February 26, 2014
L-2014-041

Re: Turkey Point Unit 3 and Unit 4
Docket Nos. 50-250 and 50-251
Florida Power and Light Company's Turkey Point Units 3 and 4, Second Six-Month Status Report in Response to March 12, 2012, Commission Order Modifying Licenses with Regard to Requirements for Mitigation Strategies for Beyond-Design-Basis External Events (Order Number EA-12-049)

Second Six Month Status Report for the Implementation of Order EA-12-049

4 Changes to Compliance Method

Modification No. 2 (Unit 3 Shown, Unit 4 similar)

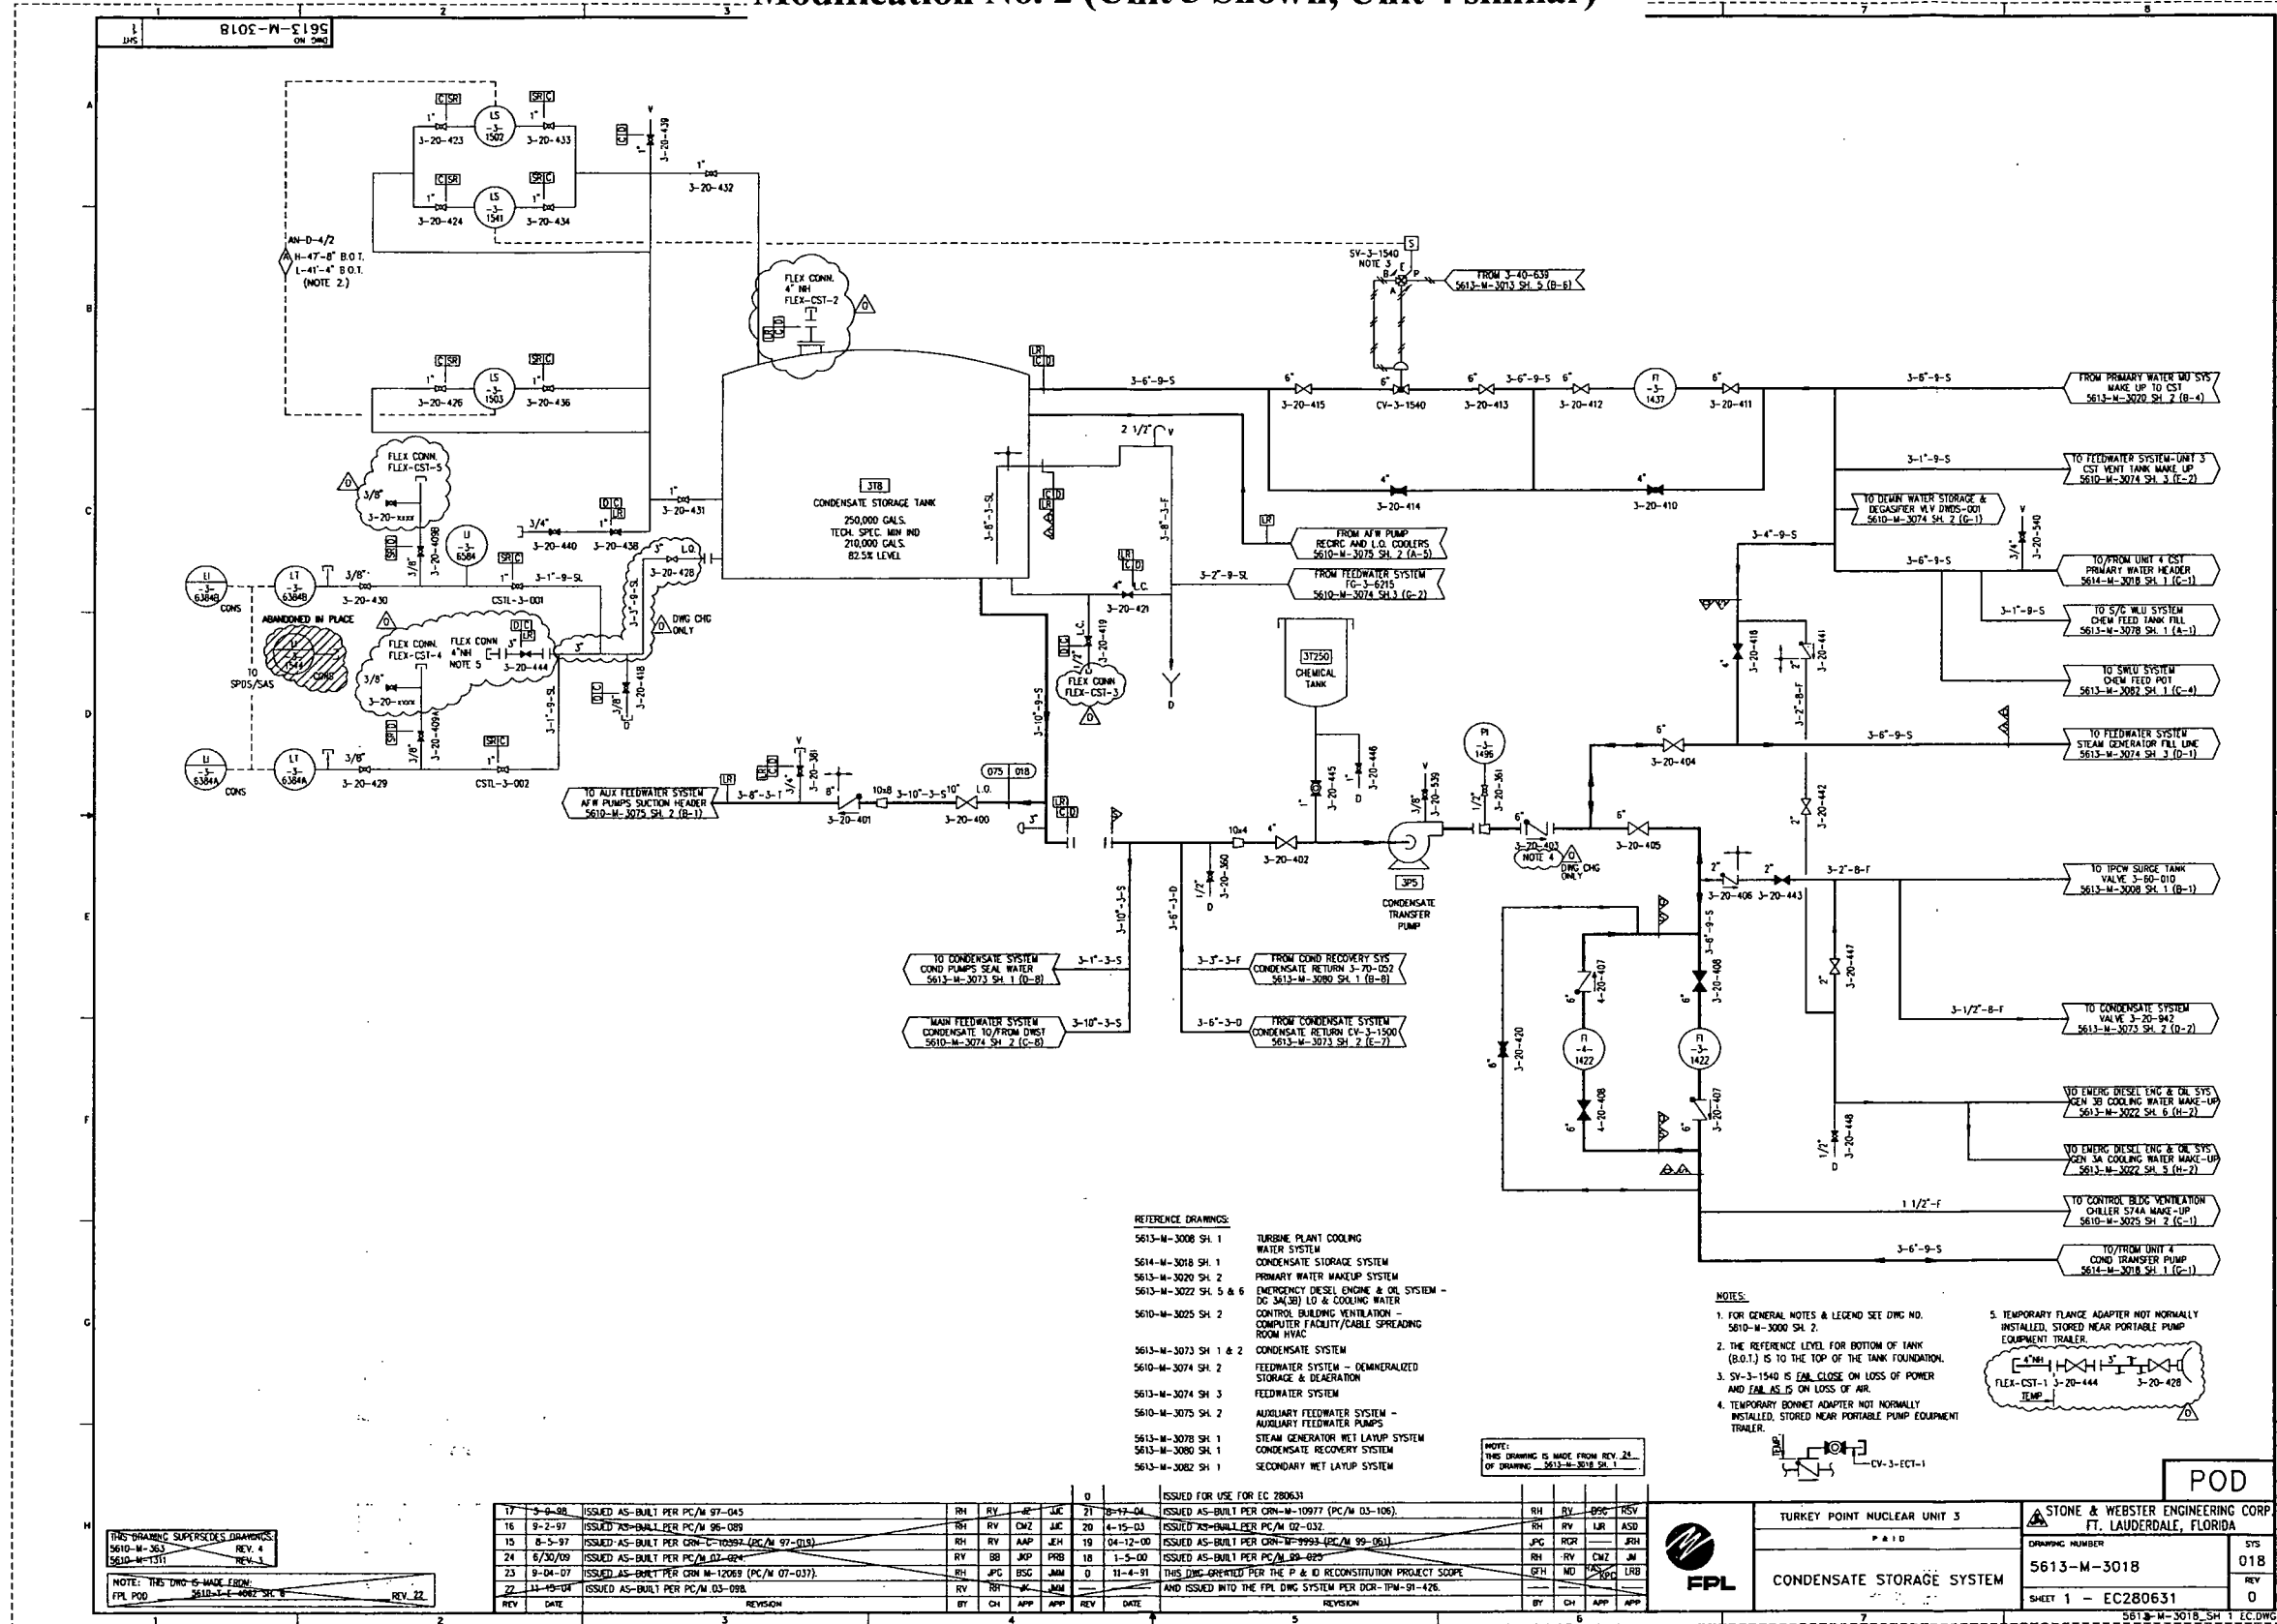
Modifications Nos. 2, Install Isolation Valve and Hose Connections on previously capped connection off AFW Suction Header Lines for Each Condensate Storage Tank (CST).

The previous 6 month update report (Reference 3) included a sketch showing two new hose connection points to the Condensate Storage Tank (CST) for use during Phase 2 (Modification Nos. 2 and 4). Modification No. 2 identified adding a hose connection and valve at the CST overflow drain line as an alternate fill connection. Due to constructability and operational concerns, the hose connection for the alternative fill location will be moved to the manway on top of the CST. Modification No. 4 which is the primary means to refill the tanks has not changed. A revised modification No. 2 conceptual sketch has been provided in Attachment 1. This change will not affect the strategy or ability to maintain core cooling and heat removal by equipment credited during Phase 2.

OIP Attachment 4
 Conceptual Sketches and Modifications
 Modification No. 5

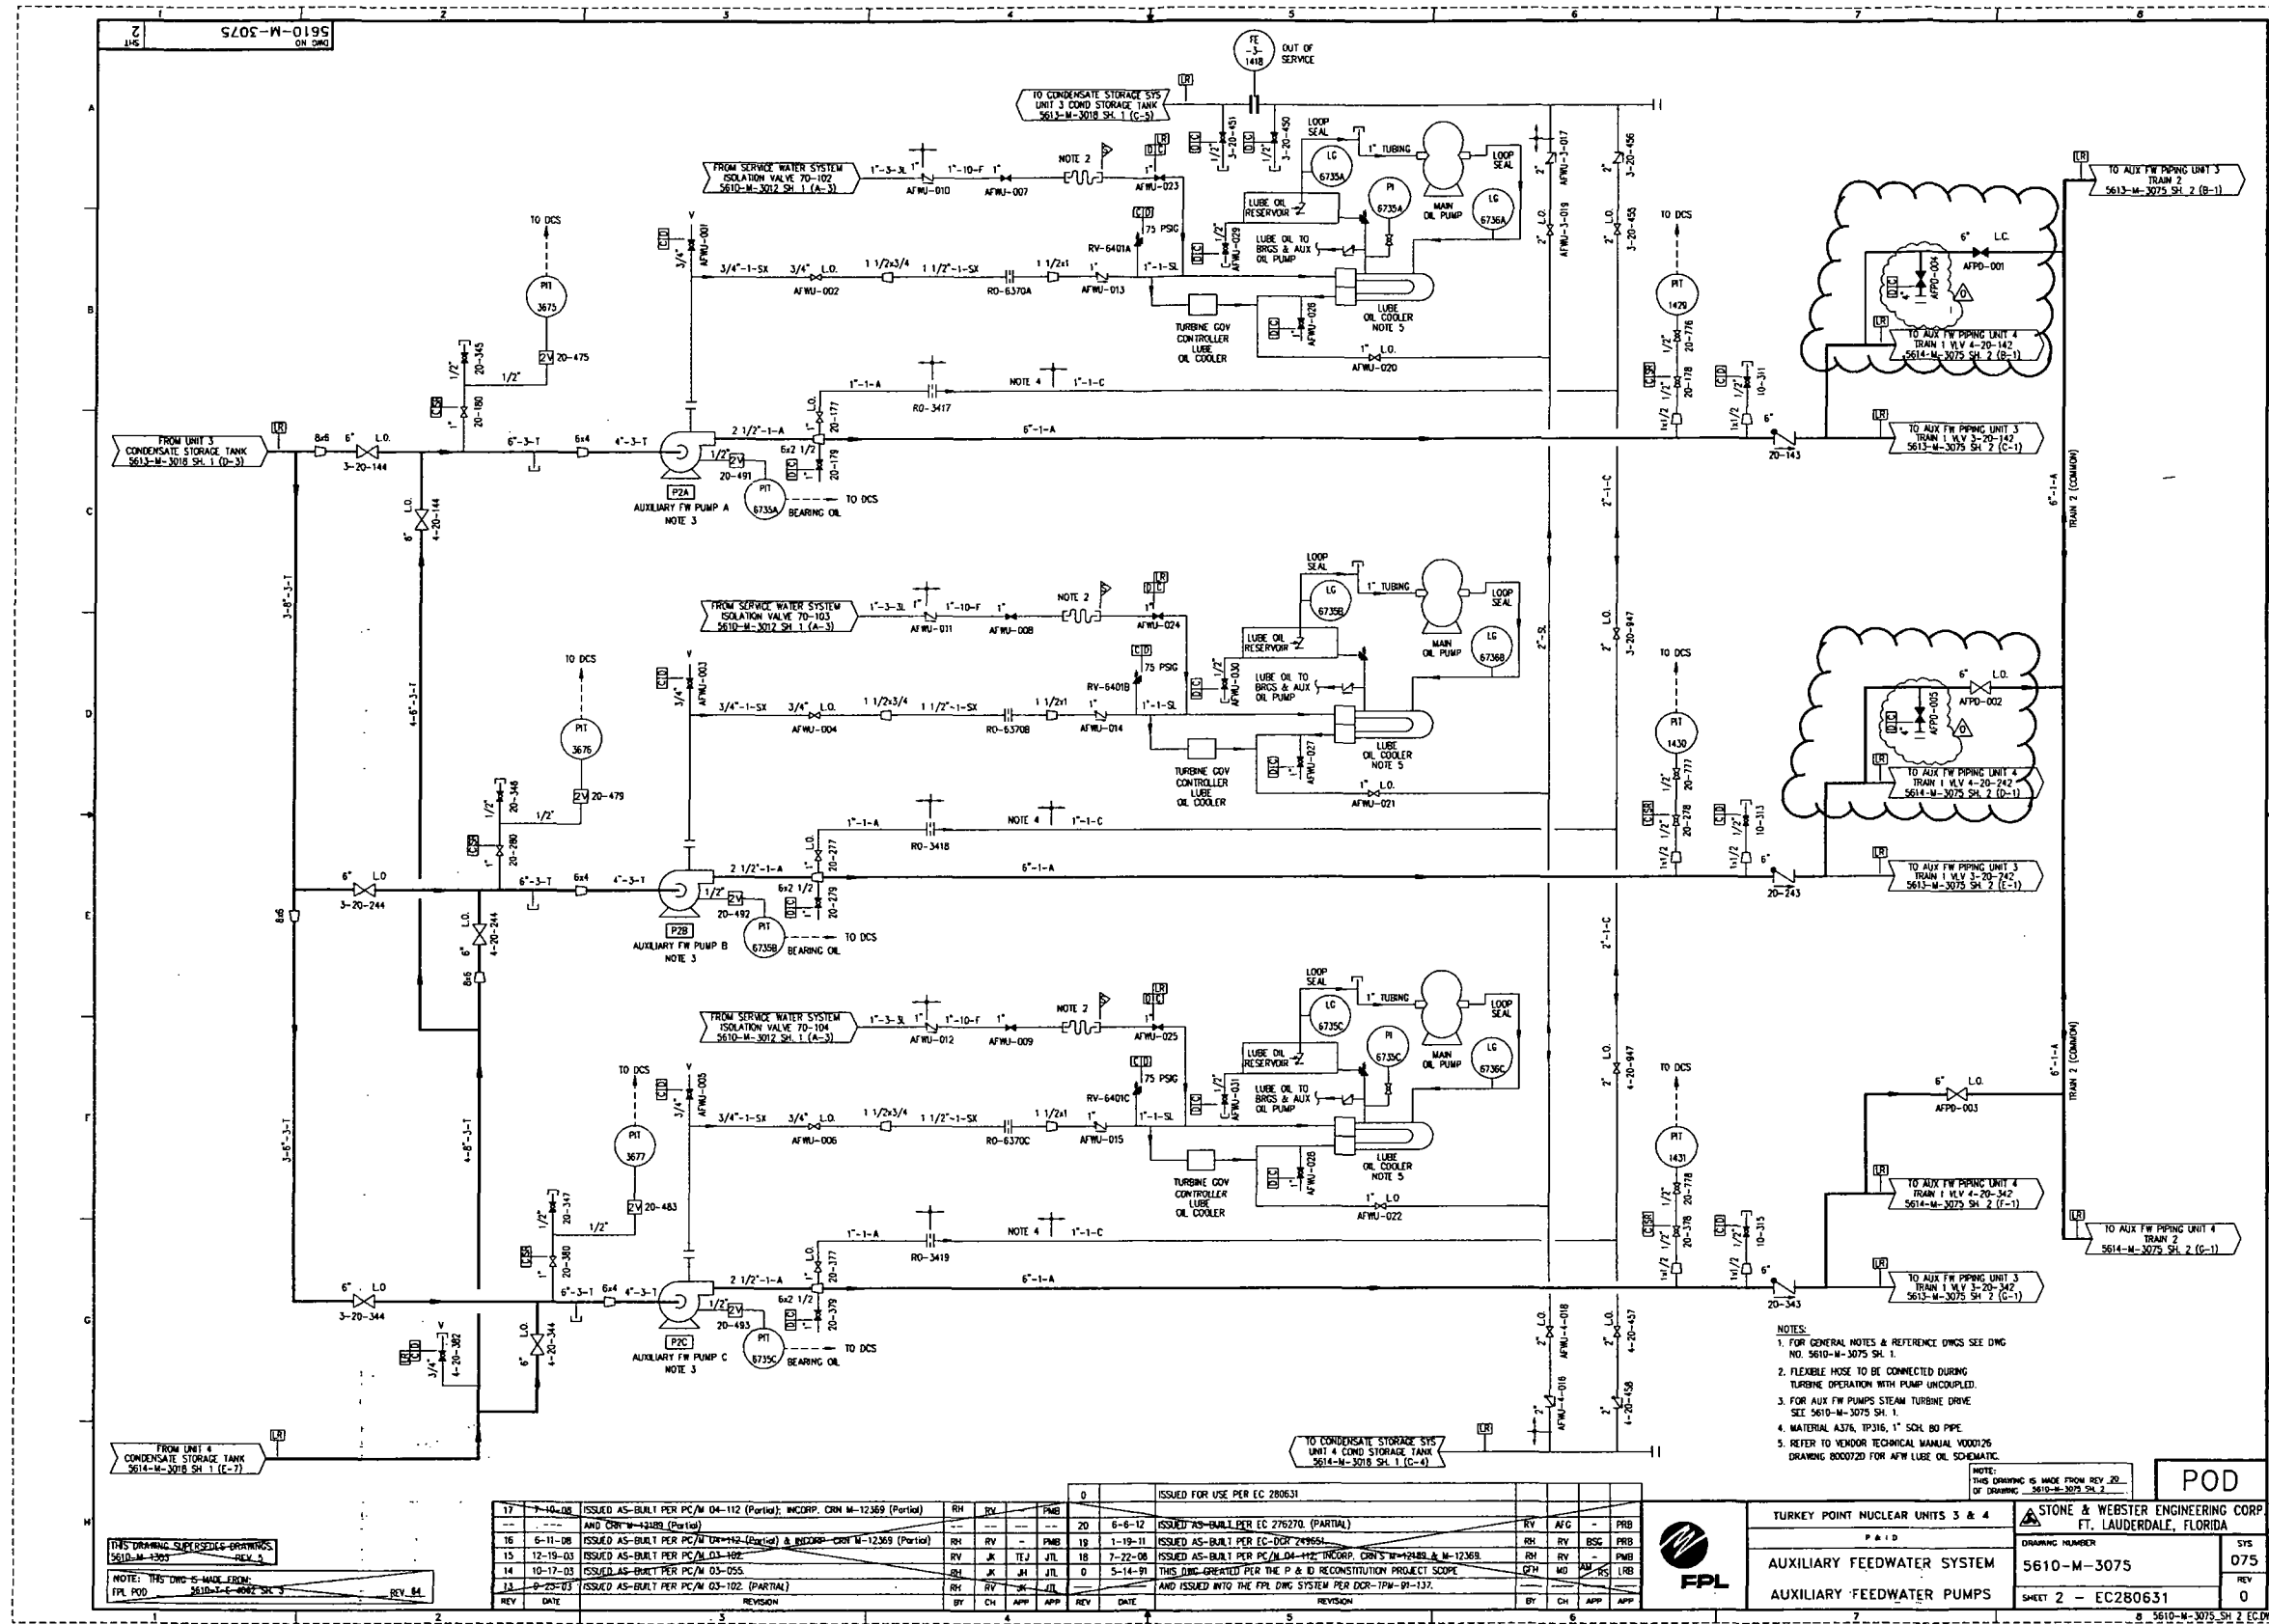
Modification No. 5, Install isolation valve and hose connections at the Steam Generator Wet Layup (SGWLU) spectacle flanges for each individual SG.

The Overall Integrated Plan submittal (Reference 1, Attachment 4) included a sketch showing a new valve and hose connection at the SG wet layup spectacle flange (Modification No. 5). The configuration of this connection has been changed to reduce deployment time for connecting the steam generator FLEX pump. Two permanent tees with isolation valves and hose connections will be added to the common AFW discharge header on the 18 ft elevation of the turbine building. This change reduces the hose connections from six to two and eliminates having to deploy hoses from the 18 ft elevation of the turbine building up to the Feedwater (FW) platform on the 42 ft elevation. A revised modification No. 5 conceptual sketch has been provided in Attachment 2. The new connection points are within robust structures and the change will not affect the strategy or the ability to maintain core cooling and heat removal by equipment credited during Phase 2.
